April 5th 2016

Mr Larry Long
Associate Administrator for Enforcement,
National Highway Traffic Safety Administration (NHTSA)
1200 New Jersey Avenue S.E.
Washington, D.C. 20590
e-mail address: tsb@dot.gov

Per Chapter V – National Highway Traffic Safety Administration, Department of Transportation, Part 579 - Reporting of information and communications about potential defect, under 579.5 Notices, bulletins, customer satisfaction campaigns, consumer advisories and other communications, Prevost is submitting an electronic copy of documentations sent to our customers during **the month of March 2016**.

a. Vehicle Brand: Prevost (EWR# 000650)

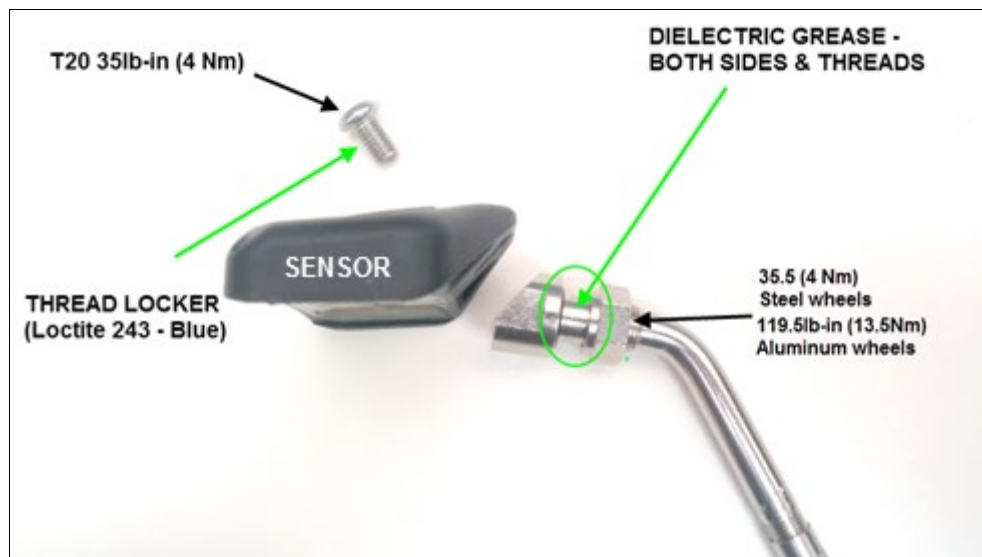
The Beru sensors used on Prevost vehicles to monitor tire pressure (TPMS system) are being replaced by new Huf sensors and their corresponding stainless valves stems.

Since the older and newer sensors are using different valve stems, replacement of a defective sensor on older vehicles will require the use of a new kit number (valve stem and sensor assembly).

The table below provides a quick overview between the older and newer part numbers depending on wheel application. Replacement and complementary part numbers are also provided.

Wheel Application	Old Valve & Sensor assembly part #	New Valve & Sensor assembly part #	Valve type	New replacement valve #
Super Single Alu 14"	651125	650022		650013
365 Alu 10.5"	651127	650023		650014
315 Alu 9"	651123	650021		650015
Old 315 Alu 9" wheel	651088	650021		650015
315 Steel 8.25" wheel	651089	650024		650017
315 Steel 9" wheel		650020		650018

Sensor Only	Old part # 564078	New part # 560032	
Mounting bolt	Old part # 651084	New part # 650019	
Dielectric grease	Part # 685324		
Thread locker (Loctite 243)	Part # 680038

Figure 4

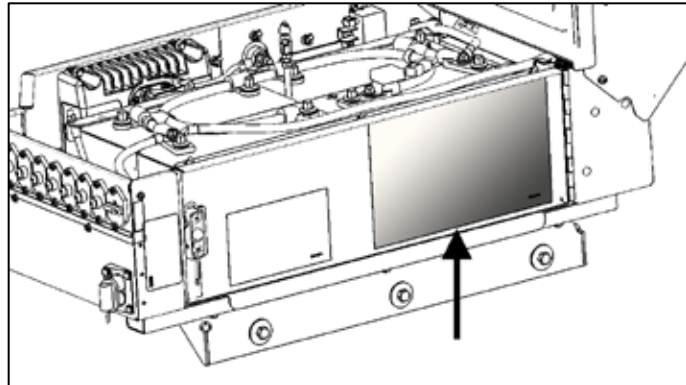
On the vehicles affected by this bulletin, replace the battery connection decal by a new version.

- 4) On the battery access door, remove existing decal #069416.
- 5) Clean the surface and affix new decal #060144.

Figure 1

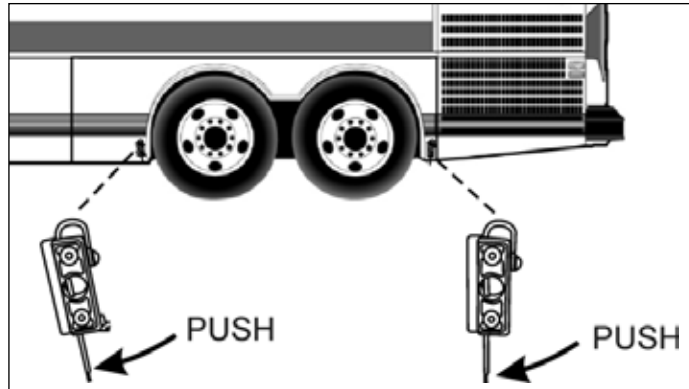
On the vehicles affected by this bulletin, replace an access panel aft of the tag axle wheel, road side.

- 3) Lift all the way up until support arm keeps the fender in the "up" position.
- 4) Remove the four screws holding the access panel in place. (Fig. 2) Keep for re-use.
- 5) Slide out and discard panel.
- 6) Replace by new access panel **050018**.
- 7) Secure new panel with the previously reserved screws.
- 8) Close the fender in reverse order and make sure it is secured in the "closed" position
